#### Thursday, March 24, 2022

# **Certificates of Appropriateness**

### Case 22-004: Rockefeller Park (Concept Plan 1/13/22) Jesse Owens Olympic Oak Plaza Martin Luther King, Jr. Drive Landscaping and Site Improvements Ward 7: Howse Project Representatives: Elise Yablonsky, University Circle, Inc.; Jayme Schwartzberg, DERU Landscape Architecture; Angelica Pozo, Artist

# **Case 22-023:** Ohio City Historic District (Concept Plan 2/10/22) **Wells Residence 4612 Clinton Avenue**

March 17, 2022

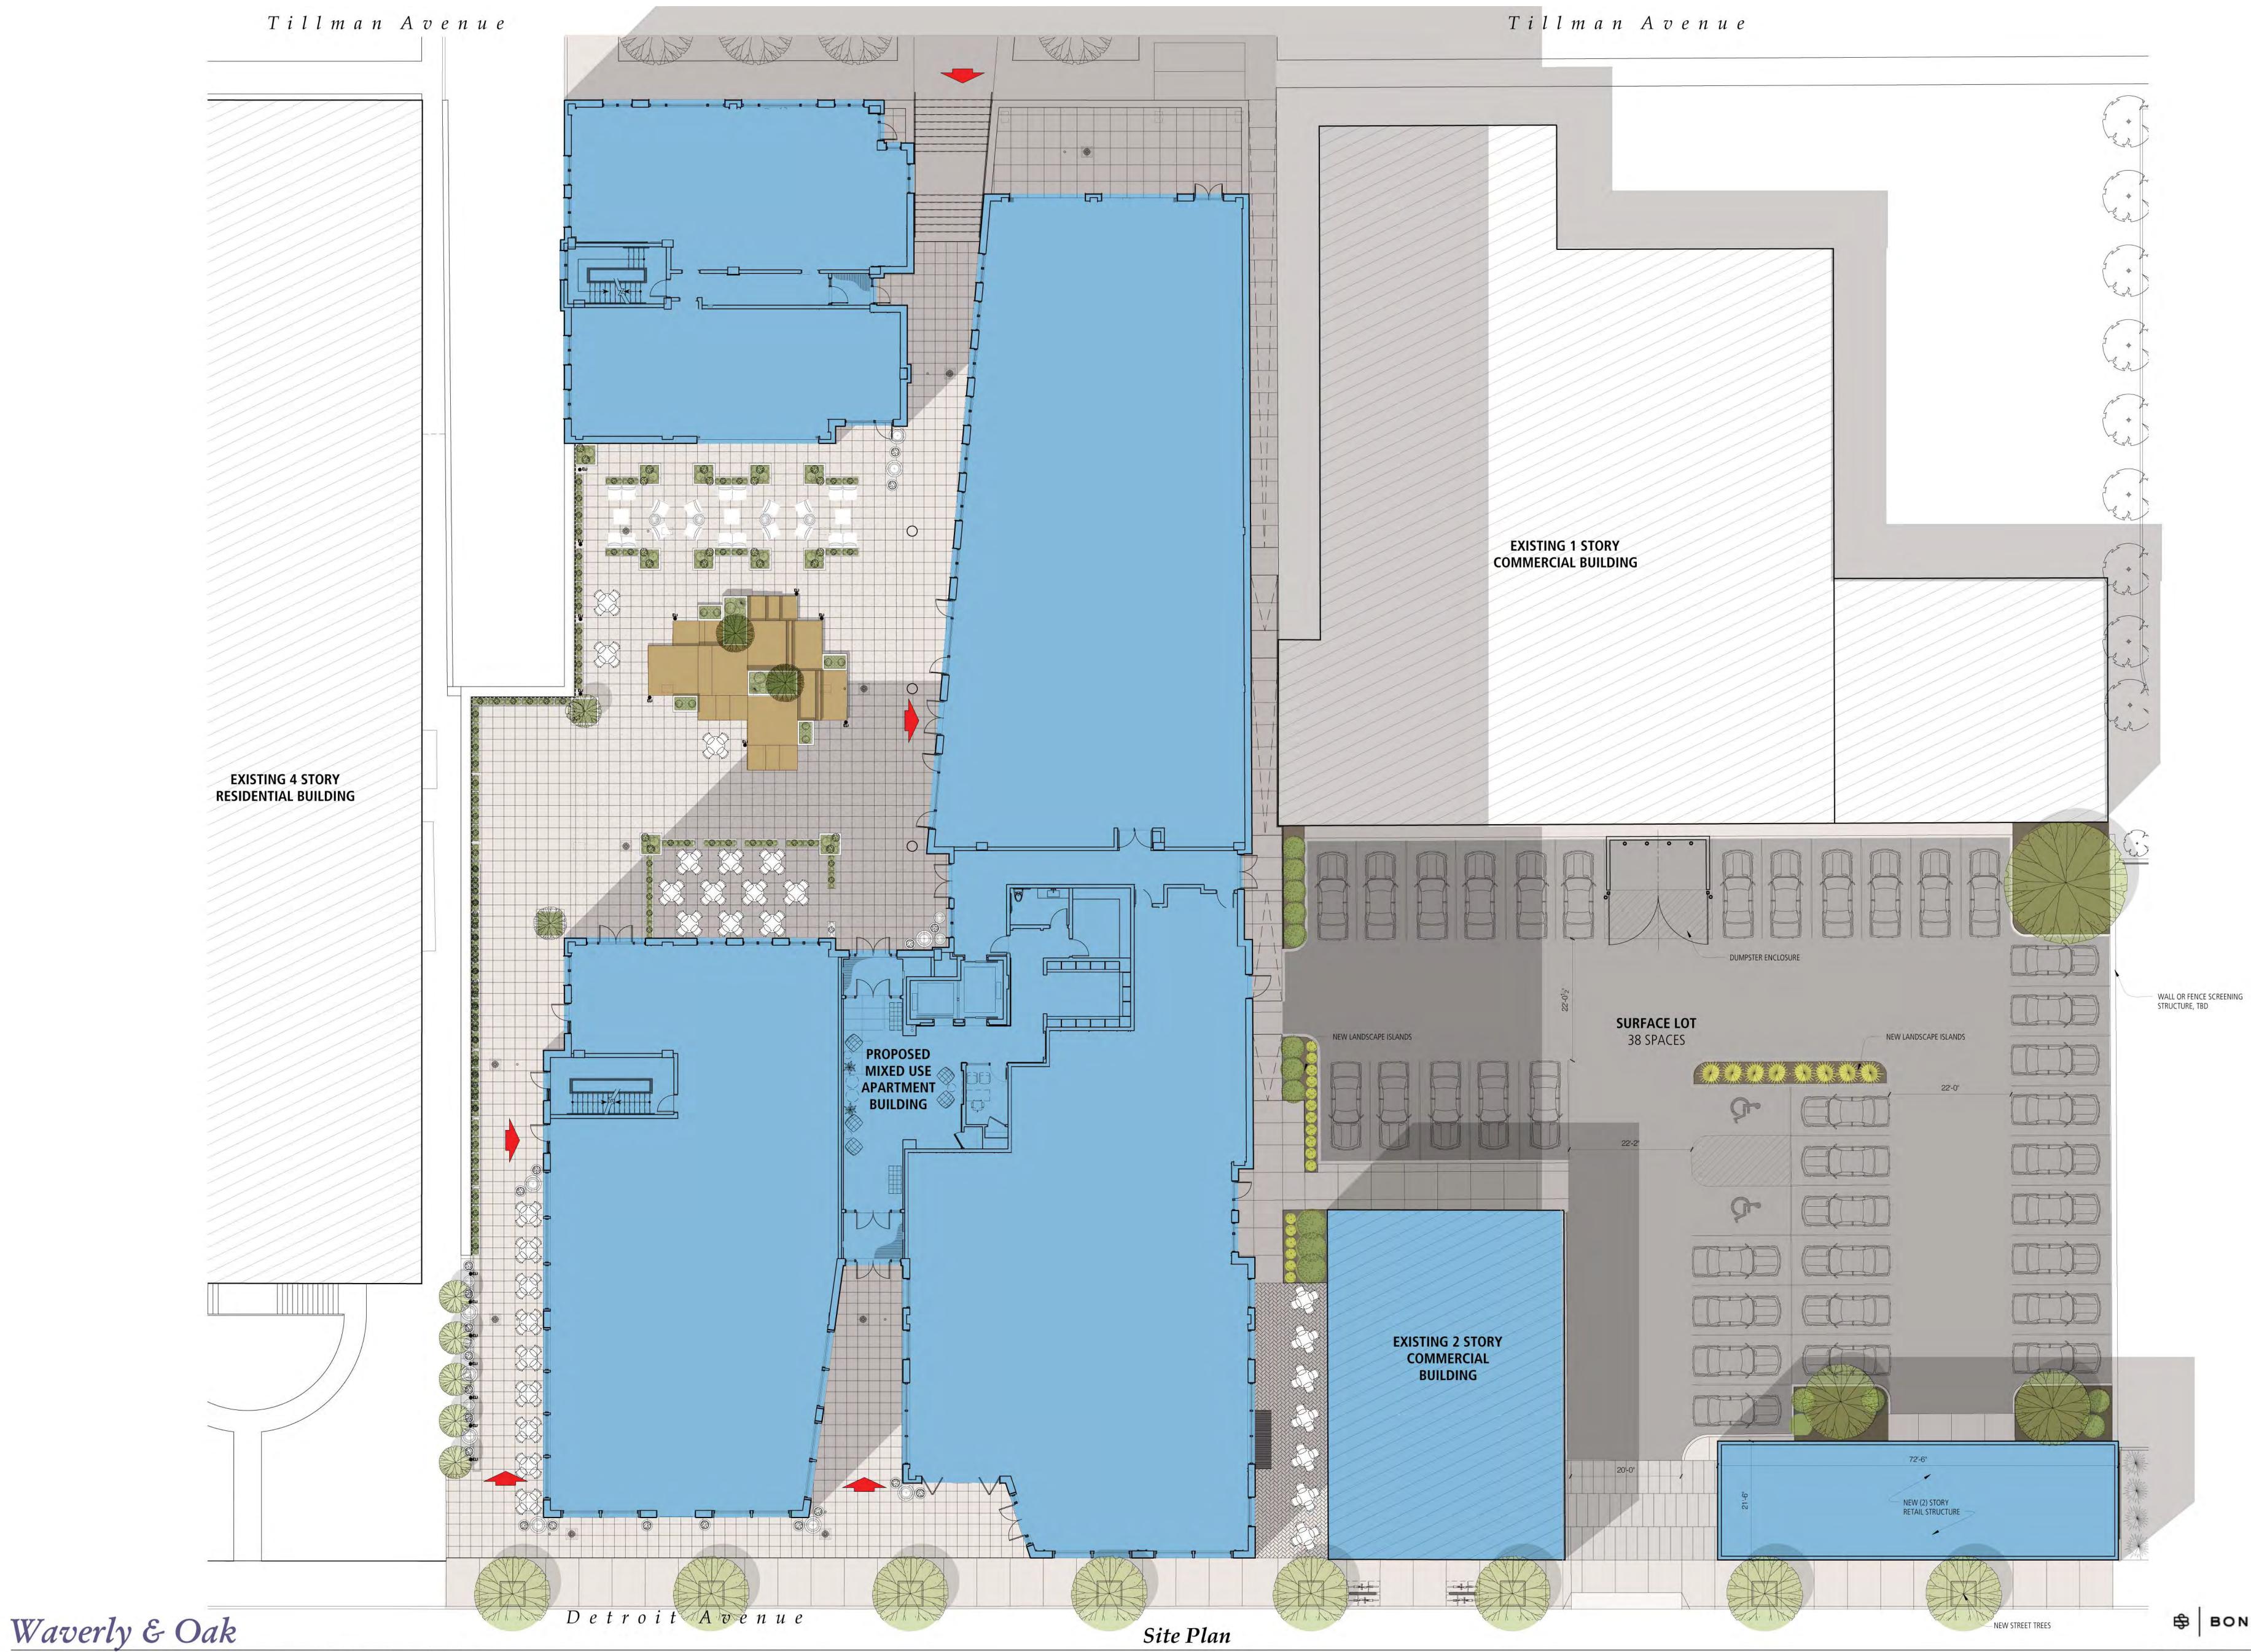
**Specifications of work proposed:** Proposal to demolish existing non-contributing structure, add temporary park, discuss potential options for future development on site. Setback increased to about 37' to meet PRO requirements (still needs conditional use)

- 1) Recommend approval of the demolition of 5416 Detroit Avenue
- 2) Recommend approval of the site plan hardscape with the pocket park hardscape to be studied for more overall greenspace, more elements for site and seating with final landscape selections to return to the committee
